ILLINOIS POWER COMPANY

Docket No. 50-461

April 18, 1983

Subject: Clinton Power Station Unit 1  
SER Outstanding Issue #3 (NUREG-0853)

Figure 1: Comparison of Design Basis Design Time History Spectrum to Theoretical Spectra Considering Soil Amplification

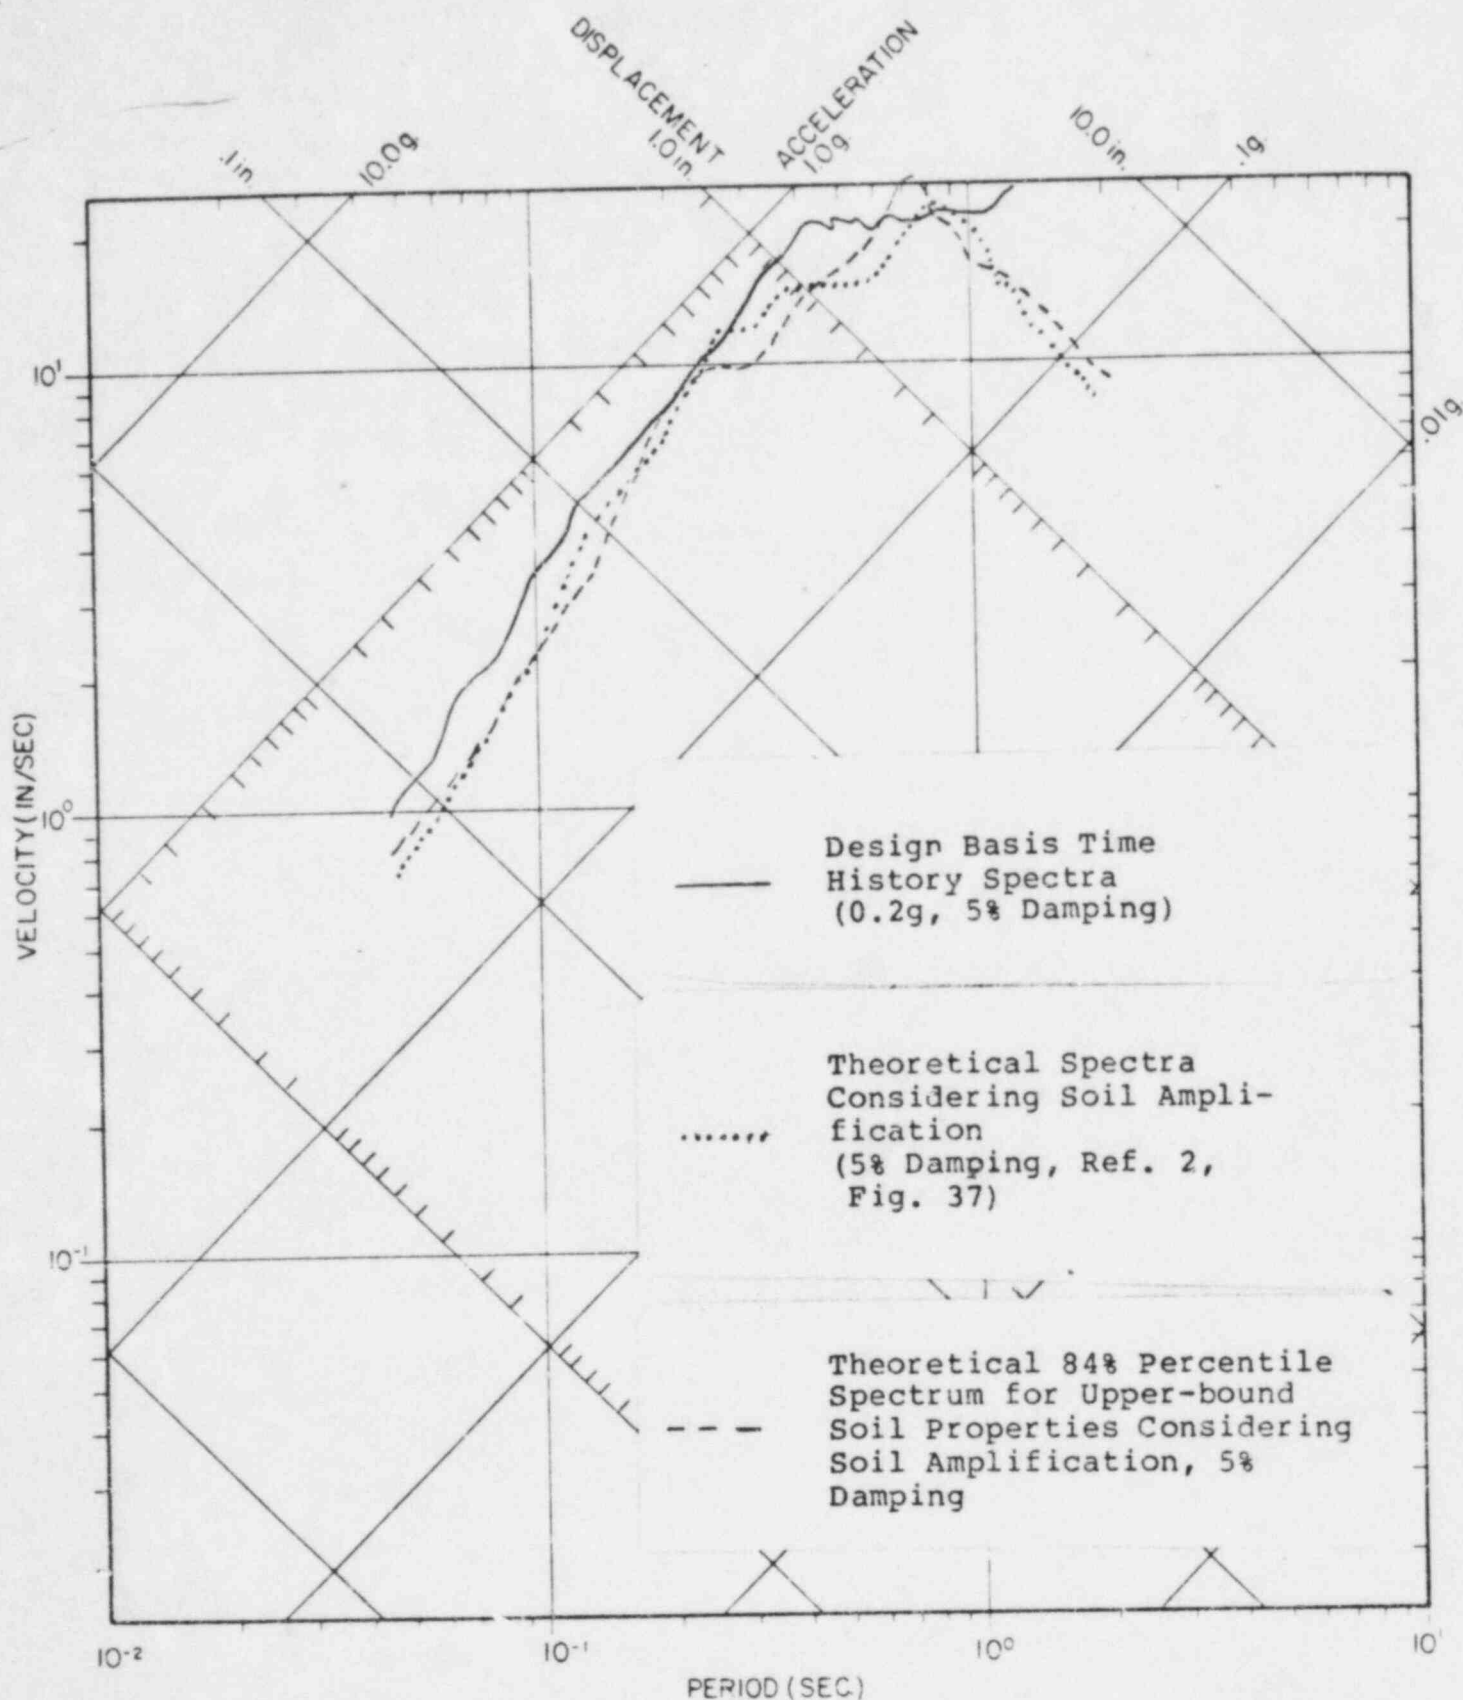
As requested by NRC in the telephone conversation with Illinois Power Company and Sargent & Lundy on April 11, attached is a copy of the revised spectra plots, incorporating the theoretical 84th percentile ground spectrum for upper-bound soil properties. The methodology to obtain this ground spectrum is the same as described in steps 2 through 5 of the referenced letter, except that the mean plus sigma values listed in Table 6 of the referenced letter for upper-bound soil properties have been used as requested by the NRC Staff.

As can be seen from the attached figure, the new ground surface spectrum is enveloped by the design basis time-history spectrum for all frequencies, except in the narrow range of 1.1 to 1.6 hertz. Since there

are no structural frequencies in this range, our judgment is that the Clinton plant design is not impacted by this narrow exceedance. We propose that discussion of the revised spectra be included in the upcoming meeting at Bethesda on April 28 for resolution of SER outstanding issue #3.
